NO: CON-073
DATE: March 2016

PRODUCT: XF3H-AR FPC/FFC Connectors
TYPE: **Discontinuation** Notice

XF3H-AR FPC/FFC Connectors to be DISCONTINUED
March 30, 2017

Model **XF3H-□□55-31AR BY OMZ**

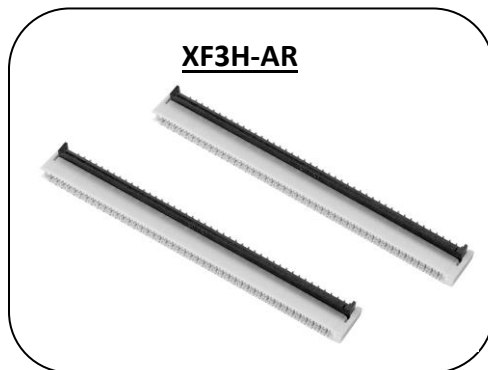
Omron will discontinue all **XF3H-AR** FPC/FFC Connector models, due to a diminishing global demand.

XF3Z -- Differences from discontinued product:

Body Color:

DISCONTINUED PRODUCT	SUGGESTED REPLACEMENT
<p>Model XF3H-2555-31AR BY OMZ Model XF3H-1355-31AR BY OMZ</p> <p>Housing Color: Natural Slider Color: Black</p>	<p>Model XF3Z-2555-31B BY OMZ Model XF3Z-1355-31B BY OMZ</p> <p>Housing Color: Black Slider Color: Brown</p>

Dimensions:

DISCONTINUED PRODUCT	SUGGESTED REPLACEMENT																														
<p>Model XF3H-2555-31AR BY OMZ Model XF3H-1355-31AR BY OMZ</p> <p>Product Height: 0.95mm</p> <table border="1" style="margin-left: auto; margin-right: auto;"> <thead> <tr> <th rowspan="2">極数 POS.</th> <th colspan="3">寸法/DIMENSIONS</th> </tr> <tr> <th>A</th> <th>B</th> <th>C</th> </tr> </thead> <tbody> <tr> <td>13</td> <td>3.6</td> <td>3.0</td> <td>5.4</td> </tr> <tr> <td>25</td> <td>7.2</td> <td>6.6</td> <td>9.0</td> </tr> </tbody> </table>	極数 POS.	寸法/DIMENSIONS			A	B	C	13	3.6	3.0	5.4	25	7.2	6.6	9.0	<p>Model XF3Z-2555-31B BY OMZ Model XF3Z-1355-31B BY OMZ</p> <p>Product Height: 1.0mm</p> <table border="1" style="margin-left: auto; margin-right: auto;"> <thead> <tr> <th rowspan="2">極数 POS.</th> <th colspan="3">寸法/DIMENSIONS</th> </tr> <tr> <th>A</th> <th>B</th> <th>C</th> </tr> </thead> <tbody> <tr> <td>13</td> <td>3.6</td> <td>3.0</td> <td>5.4</td> </tr> <tr> <td>25</td> <td>7.2</td> <td>6.6</td> <td>9.0</td> </tr> </tbody> </table>	極数 POS.	寸法/DIMENSIONS			A	B	C	13	3.6	3.0	5.4	25	7.2	6.6	9.0

DISCONTINUED PRODUCT	SUGGESTED REPLACEMENT
XF3H-5155-31AR BY OMZ	No Replacement
XF3H-4555-31AR BY OMZ	No Replacement
XF3H-3955-31AR BY OMZ	No Replacement
XF3H-3555-31AR BY OMZ	No Replacement
XF3H-2555-31AR BY OMZ	XF3Z-2555-31B BY OMZ
XF3H-1355-31AR BY OMZ	XF3Z-1355-31B BY OMZ
